RELEASE FOR CONSTRUCTION
AS NOTED FOR PLAN REVIEW
DEVELOPMENT SERVICES
LEE'S SUMMIT, MISSOURI
04/30/2024

SAB HOMES, INC.
SONOMA 3 CAR HF105
2127 SW HOOK FARM DR. LEE'S SUMMIT, MO

3 HOMES, IN NOMA 3 CAR HF10 K FARM DR. LEE'S STRUCTURAL DETAILS & NOTES

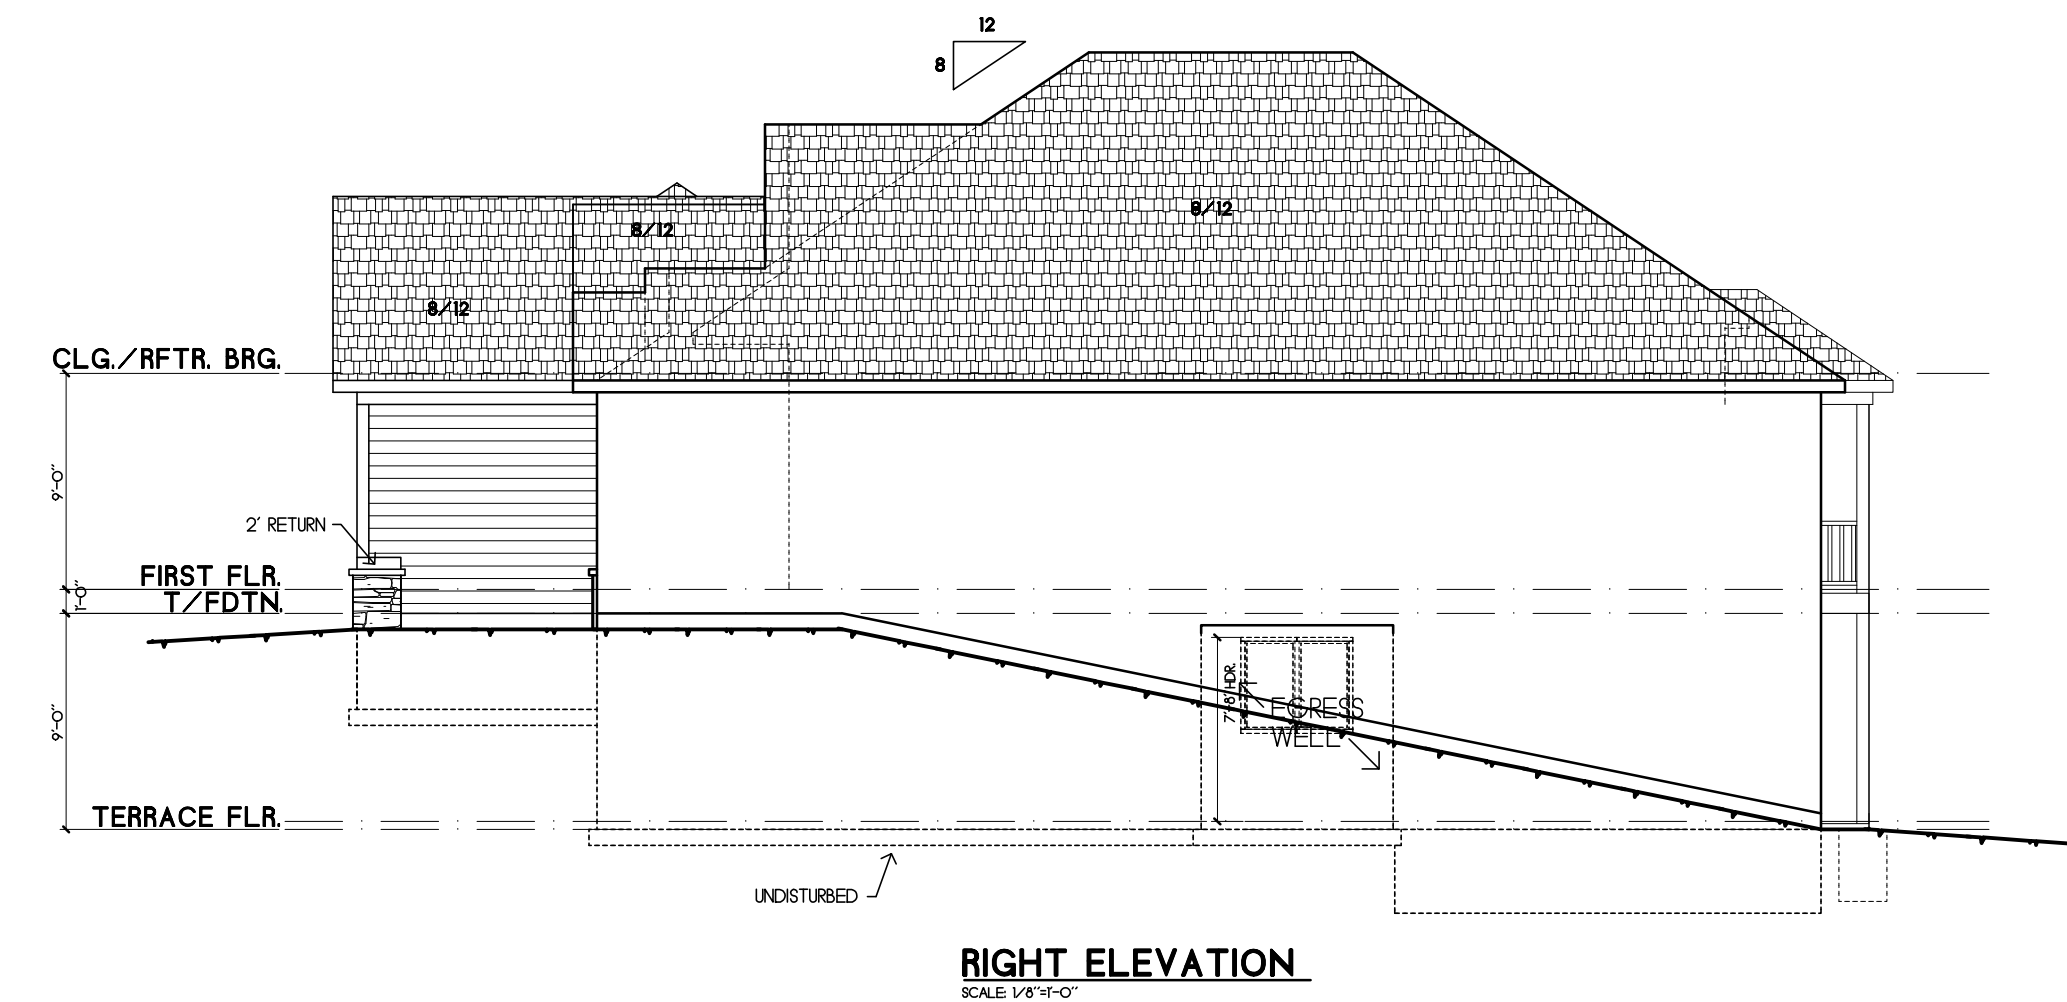
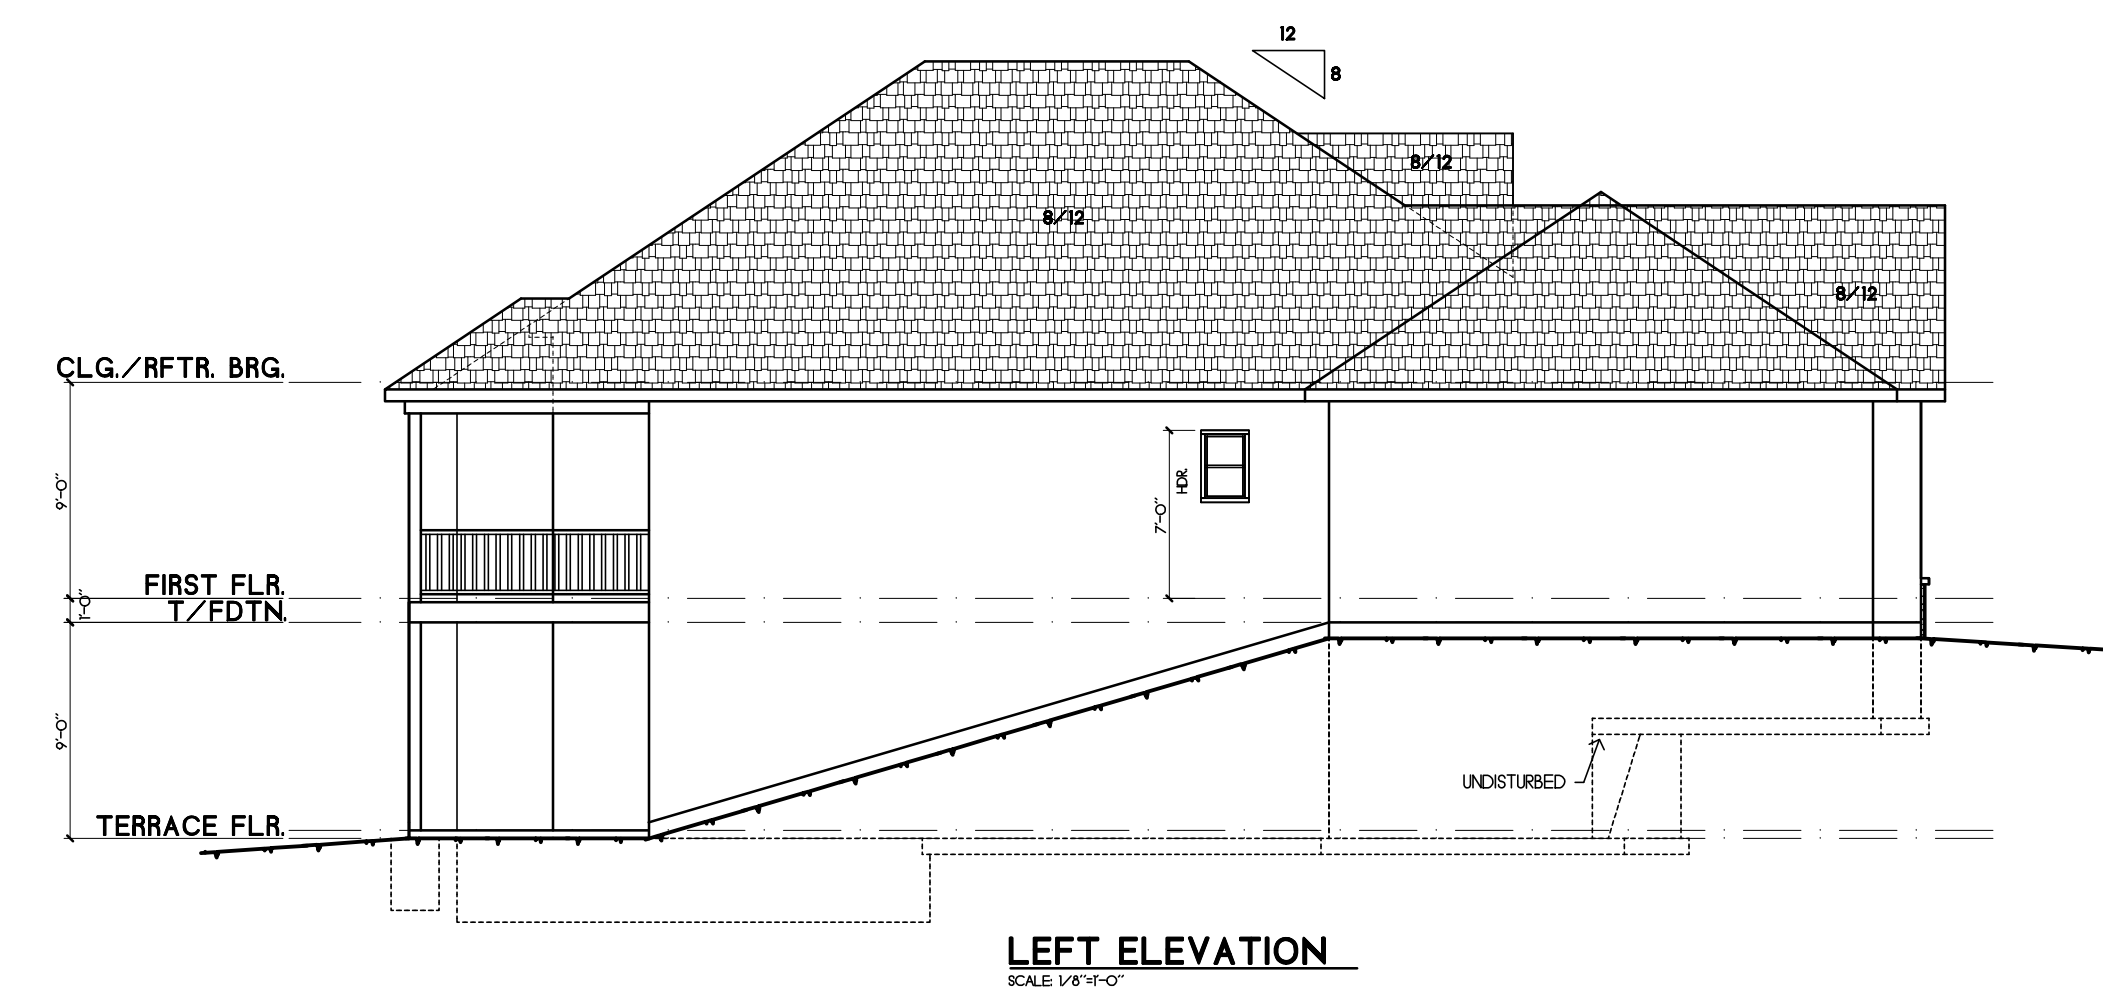
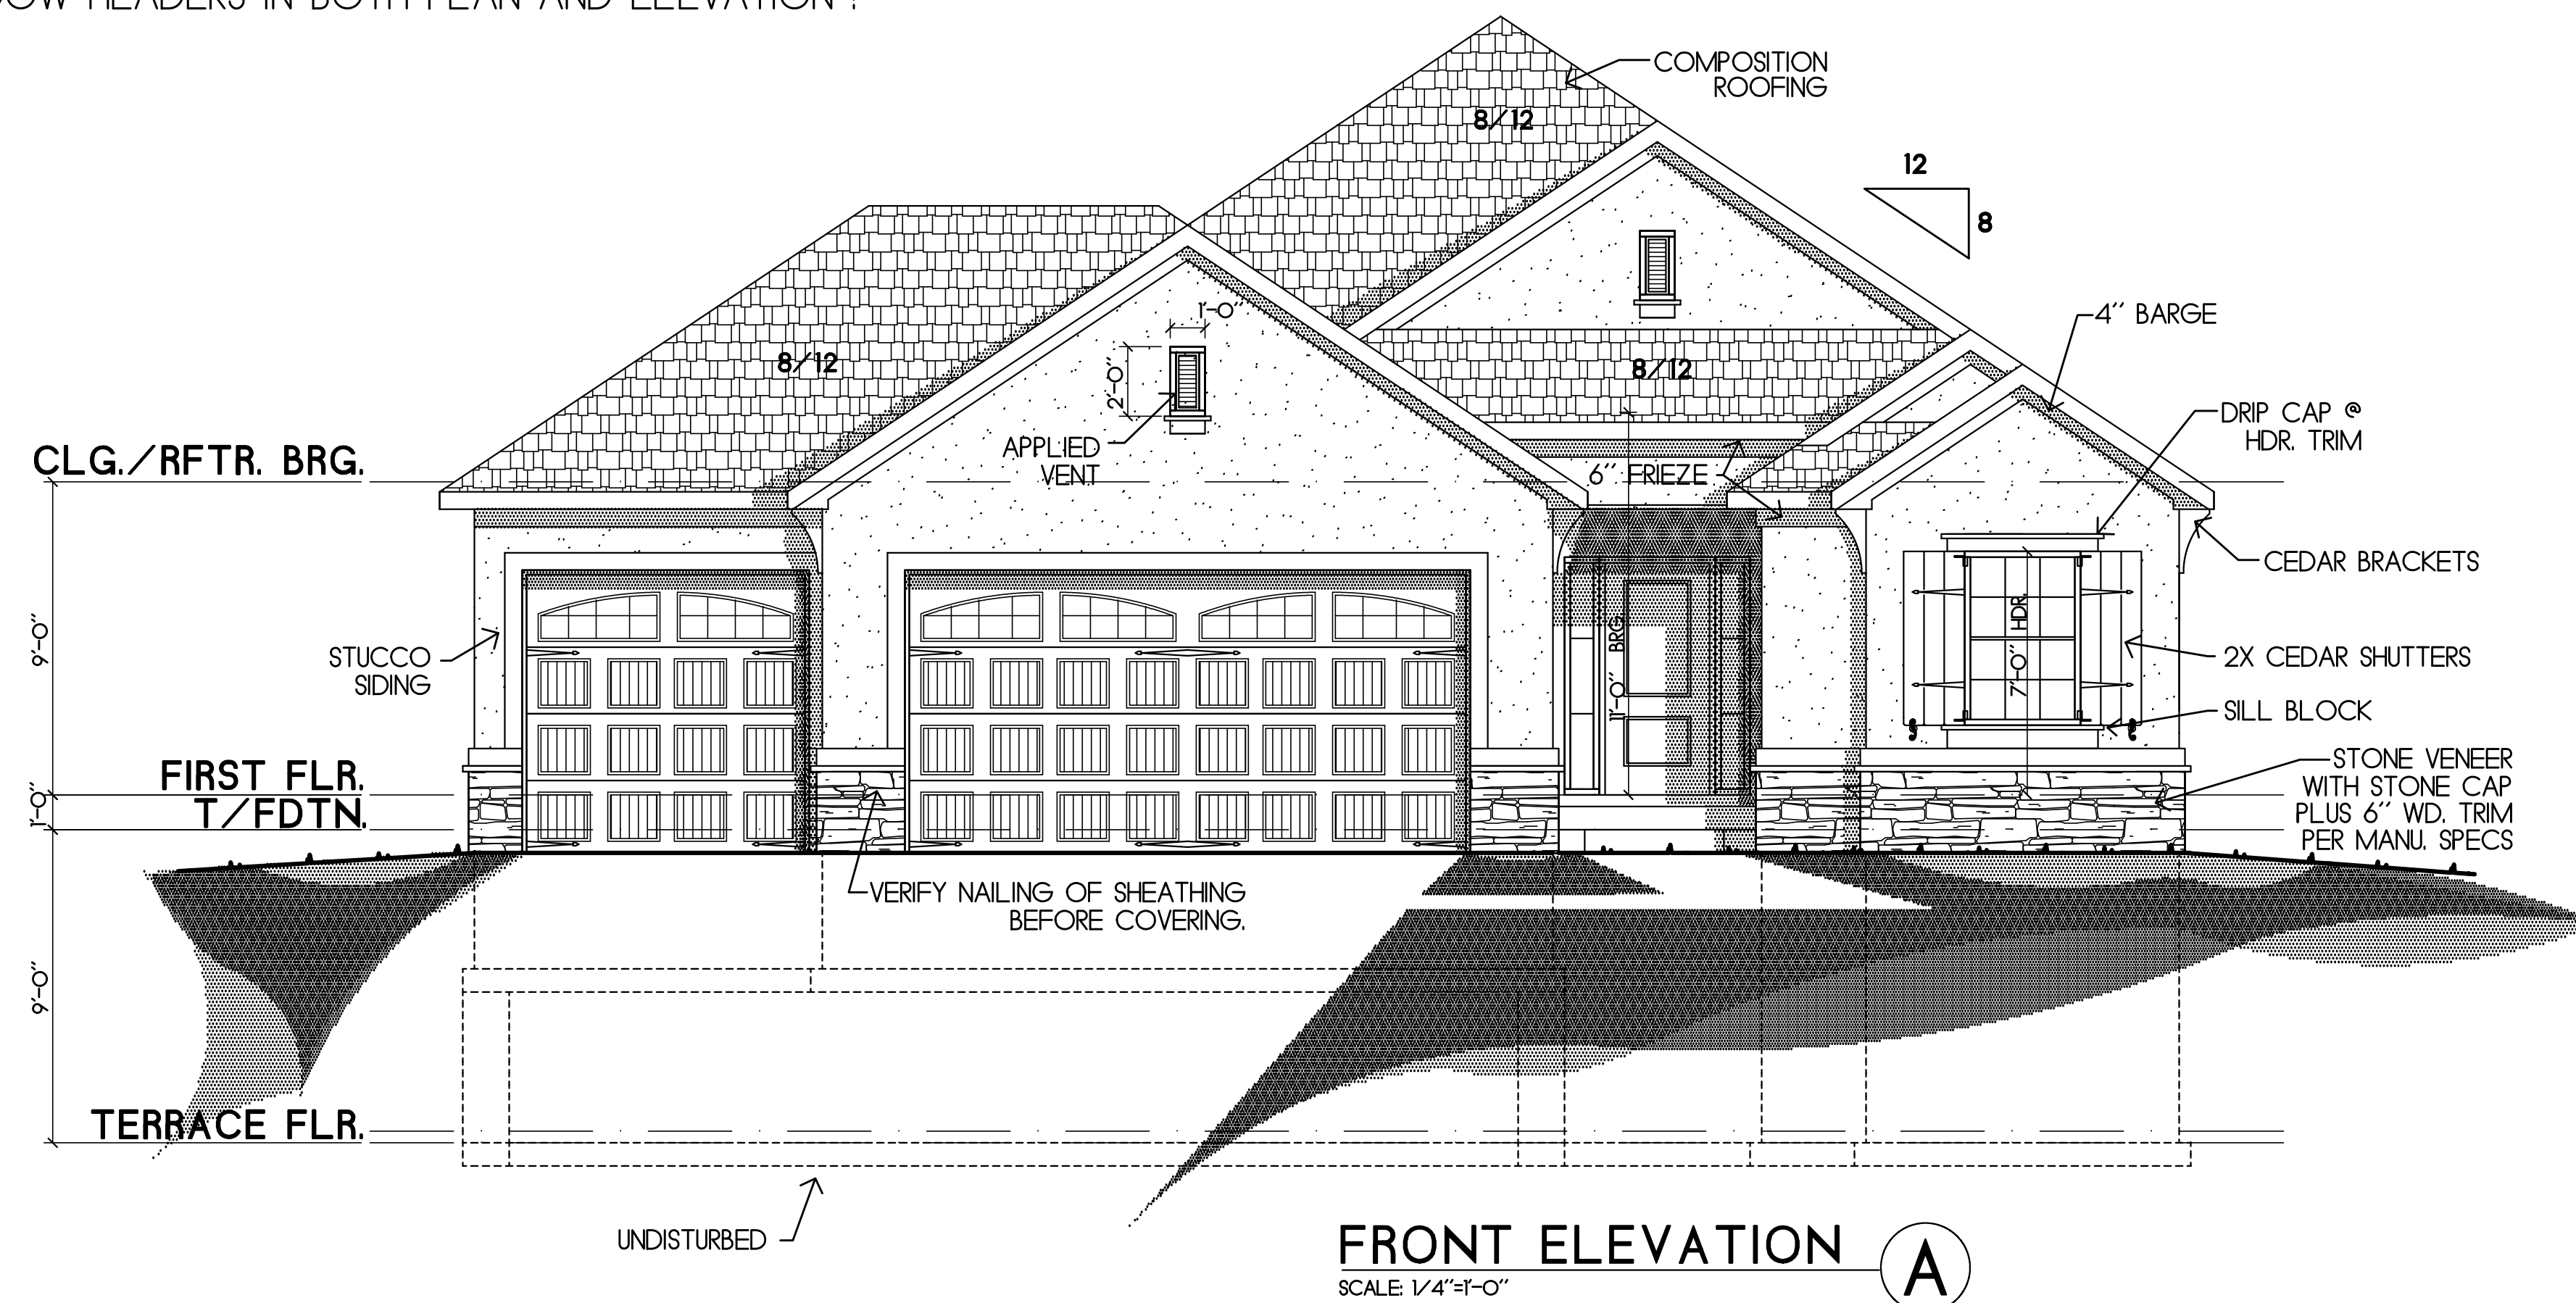
ROOF AND SOFFIT VENTS PER CODE

VERIFY WALL BEARING HEIGHTS AND WINDOW HEADERS IN BOTH PLAN AND ELEVATION !
